From: Iona Williams
Sent: 26/06/2023 4:25:53 PM
To: Council Northernbeaches Mailbox
Subject: DA2023/0647 submission response 13 ALLEYNE AVENUE, NORTH NARRABEEN, NSW 2101
Attachments: Scan 9.pdf; PastedGraphic-4.tiff;

RE: DA2023/0647 PROPOSED ALTERATIONS AND ADDITIONS

13 ALLEYNE AVENUE, NORTH NARRABEEN, NSW 2101

PROPOSED VISUAL
BUILT FORM IMPACTS

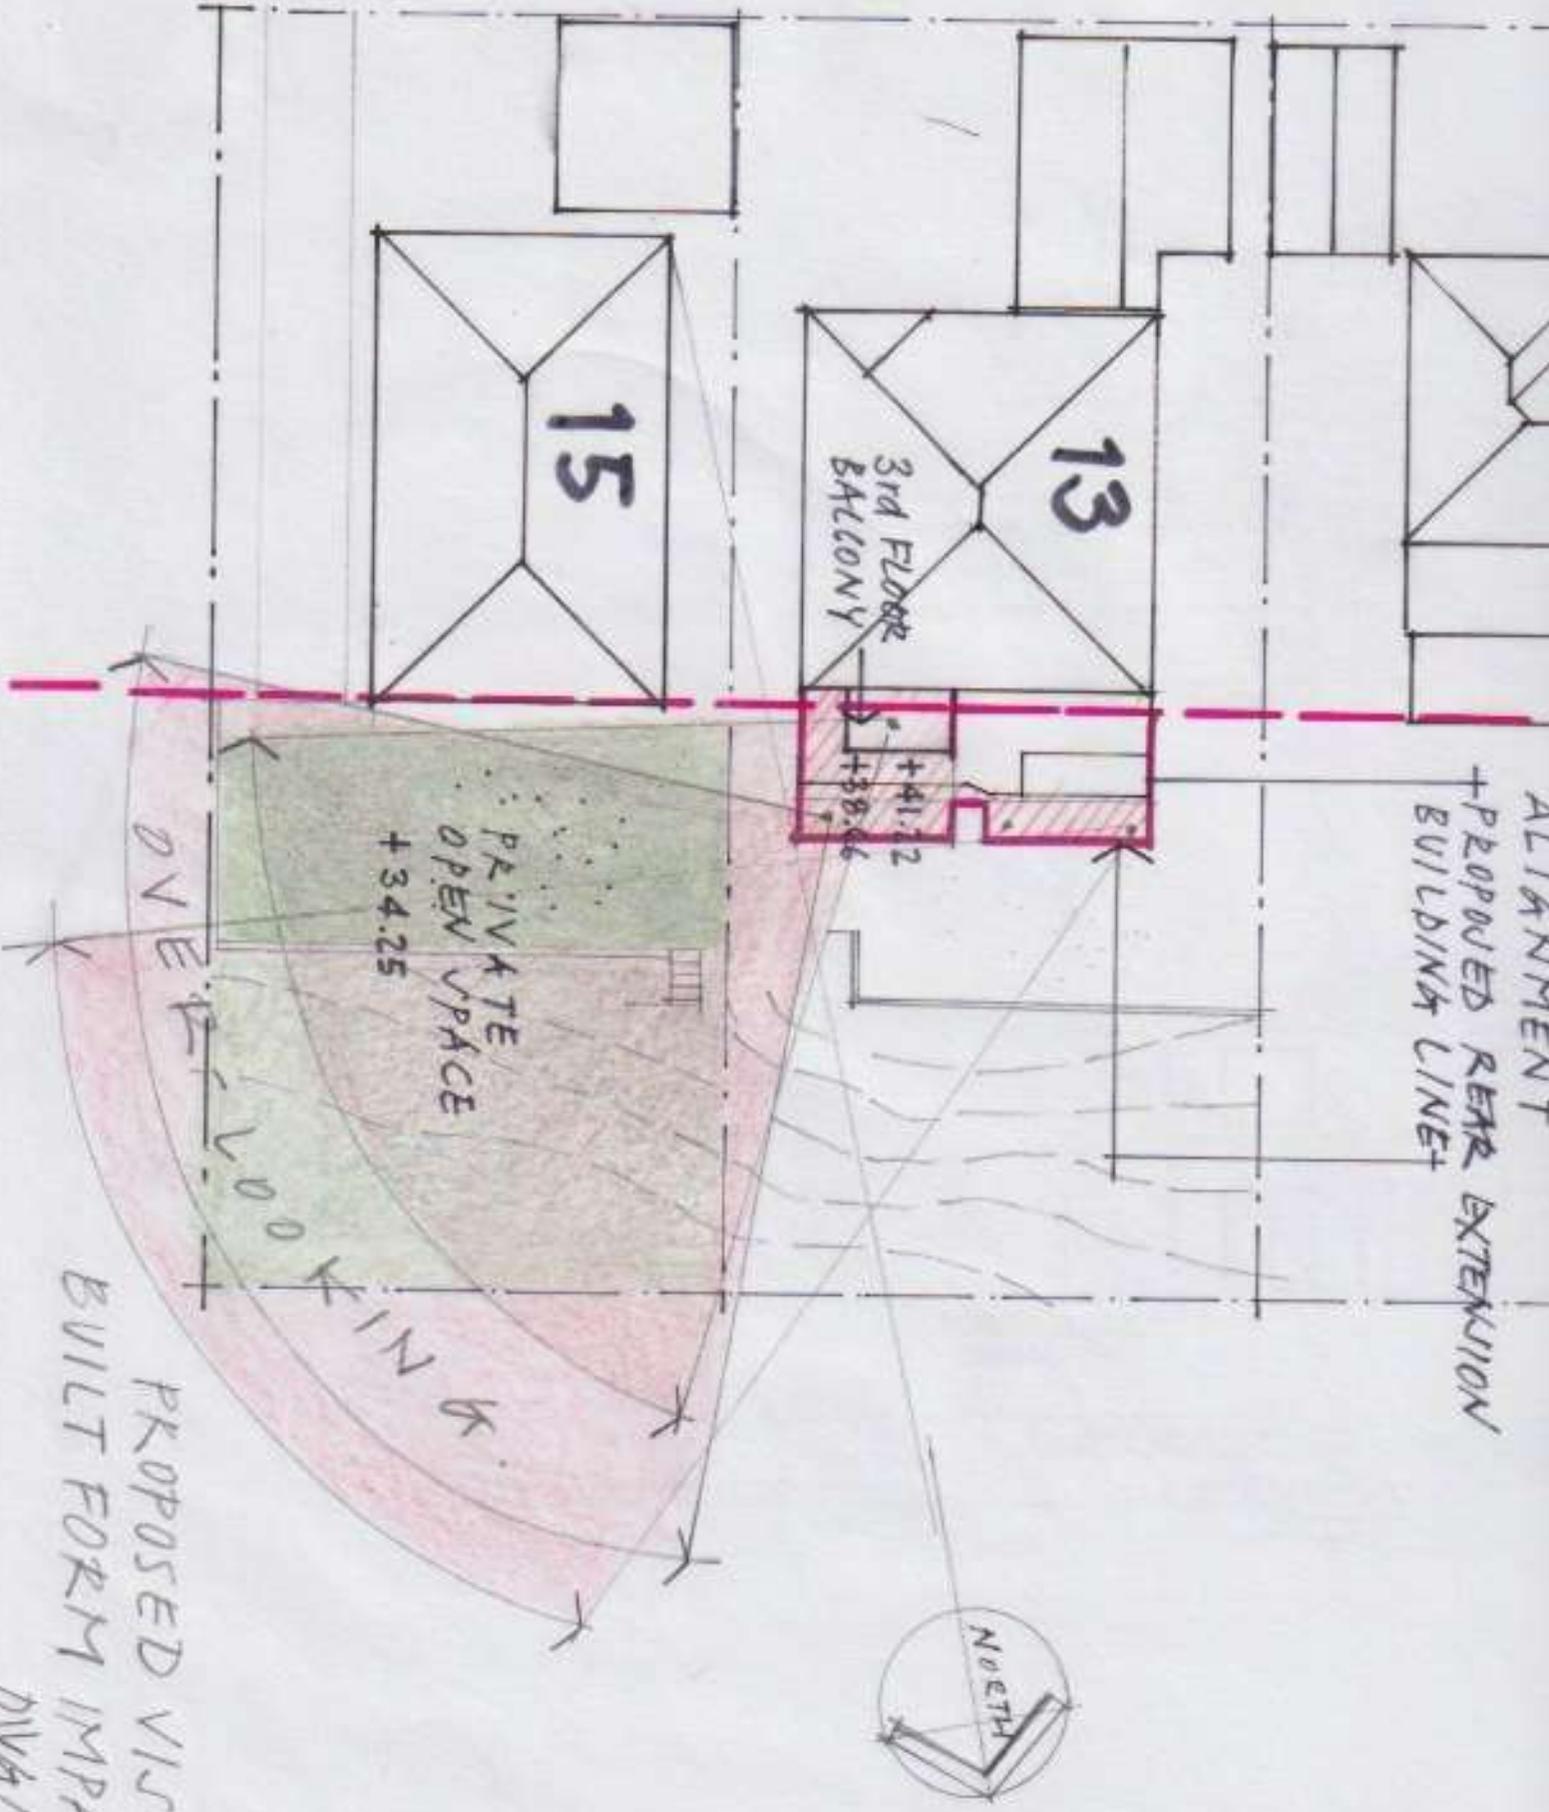
Please refer to the Proposed Built Form Visual Impacts Dwg. No. 1

But the effects of the height and extra bulk and scale of no.13 (designed as an almost sheer 3 storey 'wall' of built form) obviously does not take into account the slope of the land by 'breaking' up the bulk to 'step down the slope'.

Whereas the neighbour's home at No.15 is far more appropriately designed and sited as it 'steps down the slope' (while also creating a more 'earth sheltered' and energy efficient home).but by doing this it is adversely impacted by the adjoining proposal that does not account for natural slope of the land.

While the proposed new roof and the proposed verandah extension will also protrude way past the existing built form alignment pattern established by the neighbouring properties.

Additionally there are detrimental impacts to the visual privacy and overlooking caused to the neighbouring property at No.15 caused by the extent of the rear deck’s height, bulk and scale.
